**1 Products affected**

Product Change Notification					PCN EC11-New Connections		
owner	creation date	release date	released by	change order	rev	page	D10-067-746
huberth	02.09.2022	12.09.2022	muehlema	2024666	A	1 of 2

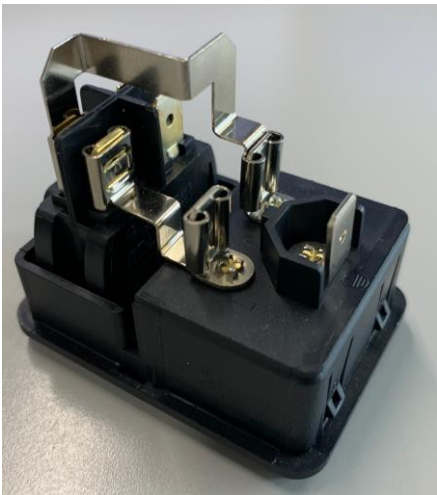
- Wire connection between inlet and switch replaced by brass brackets

- Improved assembly process
- Lower installation depth

| <ul style="list-style-type: none"> <li><input checked="" type="checkbox"/> Form</li> <li><input type="checkbox"/> Fit</li> <li><input type="checkbox"/> Function</li> <li><input type="checkbox"/> Manufacturing</li> <li><input type="checkbox"/> Label</li> <li><input type="checkbox"/> Packaging</li> </ul> | <p>Verify installation dimension and check insulation requirements.<br/>If required use rear cover RC 320-07 (Article 3-125-667).</p> |
